Modification Recommended Service Note

N8921A - Autoranging System DC Power Supply, 200V, 70A, 5000W, 208 VAC

Serial Numbers: DE14290000 - DE15369999 without manufacturing ID Version "B"

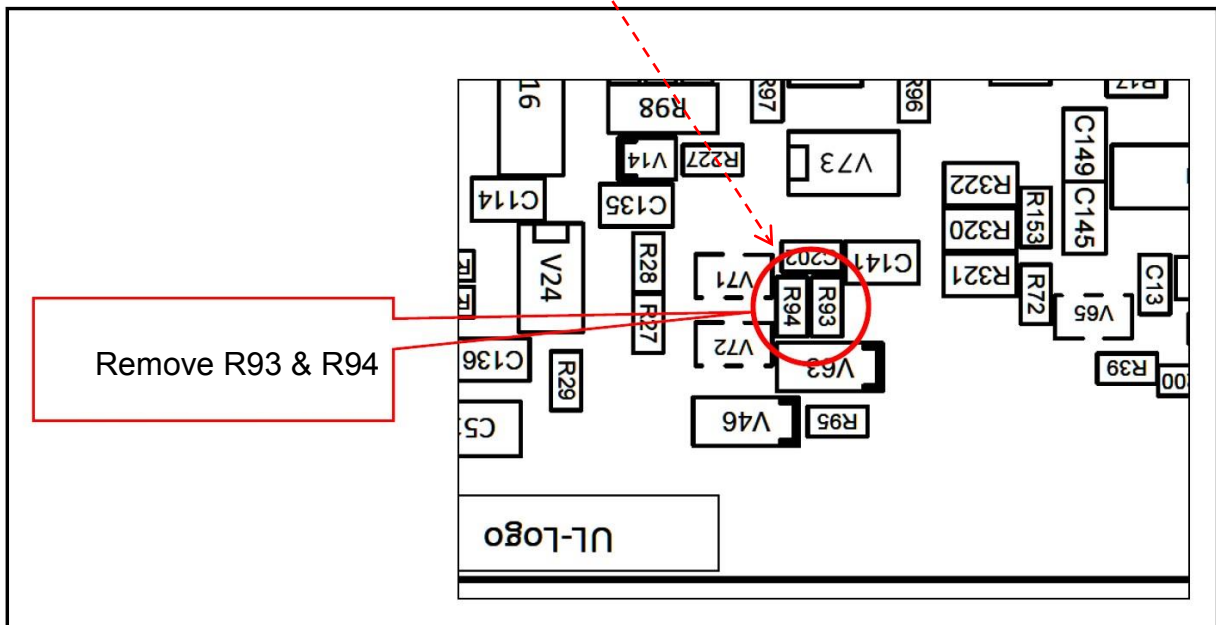
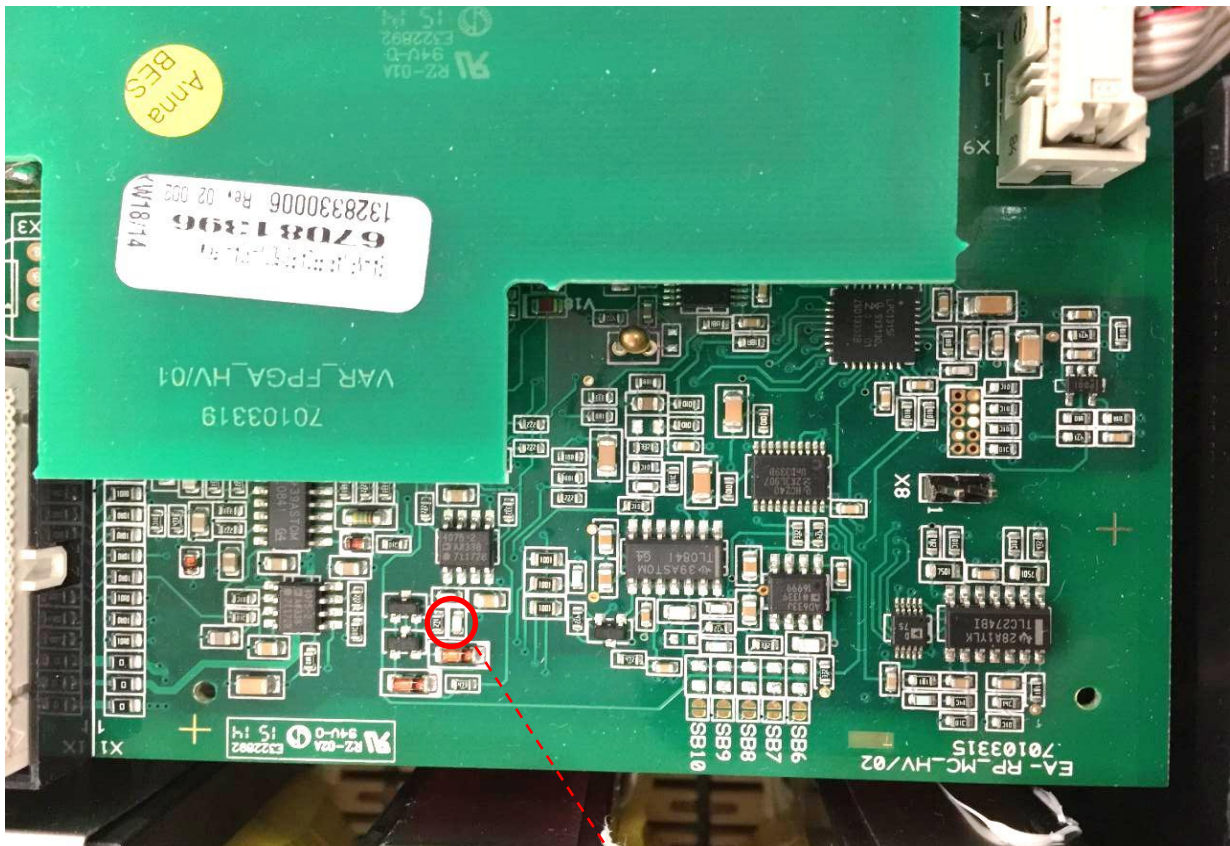
- 1) Remove acMains cable from power source.
- 2) Wait 5 minutes
- 3) Remove top cover from instrument.
- 4) In the 5kW units (viewed from the front of the unit), a small SMT assembly located at the right-rear of instrument will be readily visible (see below):

In the 10kW & 15kW units; although found in the same location, a black plastic cover will have to be removed to gain visibility and access to the SMT assembly. Plastic cover snaps-on and can be removed with a small screwdriver.

5) SMT resistors R93/R94 are located in red circle shown below:

Removal of two (2) surface mount resistors, R93 and R94, will correct this problem:

6) After removal of R93 & R94, re-install all covers. Instrument does NOT require recalibration after the removal of R93 & R94.

Suffix “B” added

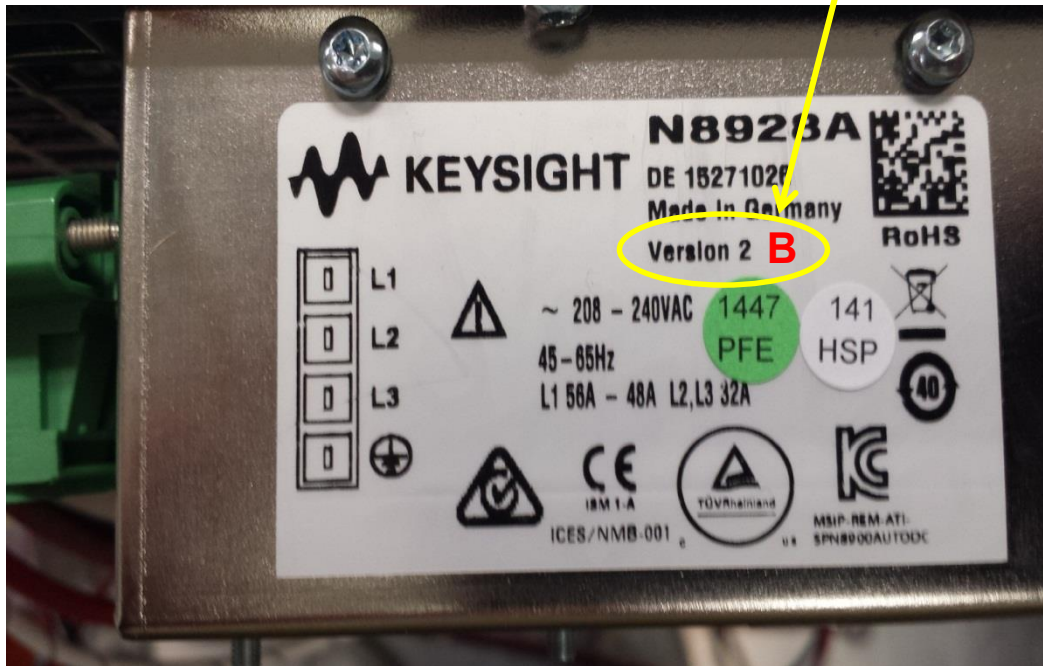
7) On the acMains label, on the rear of the instrument; use an indelible marker, to add the suffix letter “B” after the Version ID. This will assist in the tracking of modified instruments.
